RESPONSE TO REQUEST FOR ADDITIONAL INFORMATION

APR1400 Design Certification

RAI No.: 407-8447

SRP Section: 19.03 – Beyond Design Basis External Event (APR1400)

Figure 1 Locations for SFP FLEX pump connection

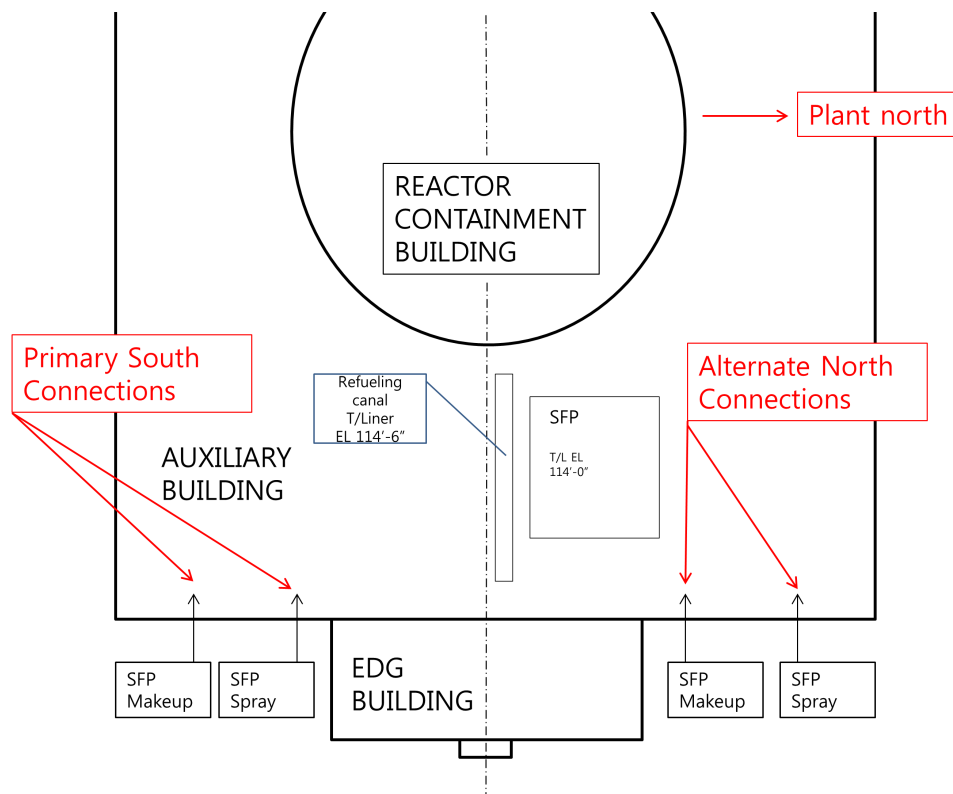
The staff reviewed the information in APR1400-E-P-NR-14005-P, "Evaluations and Design Enhancements to Incorporate Lessons Learned from Fukushima Dai-Ichi Nuclear Accident," Section 5.1.2.4.1.2, comparing it with the NEI guidance. It is not clear whether the connections being used in the proposed mitigation strategies for SFP cooling are consistent with the

guidance that the location of the connection points should provide reasonable assurance of at least one connection being available for all applicable external hazards.

The applicant is requested to clarify how the APR1400 design for connections to the FLEX equipment is consistent with the NEI guidance.

The APR1400 mitigation strategy for SFP cooling is schematically illustrated in Figures 6-2 and 6-3, and the approximate locations for makeup water connections are indicated in Figure 6-4. The APR1400 design provides two locations for SFP makeup water connections: a set of two primary connections (one for makeup and one for spray) is mounted on the outside wall of the Auxiliary Building (AB), adjacent to the south side of the Emergency Diesel Generator (EDG) building; and the alternate set of identical connections (one for makeup and one for spray) is mounted on the outside wall of AB, adjacent to the north side of the EDG building. Please refer to Figure 1 below for illustration.

Since the south and north connections are physically separated by the EDG building which is a seismic Category I reinforced concrete structure and also designed to withstand the effects of internal and external hazards. This configuration provides reasonable assurance of at least one connection being available; and is consistent with the guidance in Section 3.2.2 of NEI 12-06.
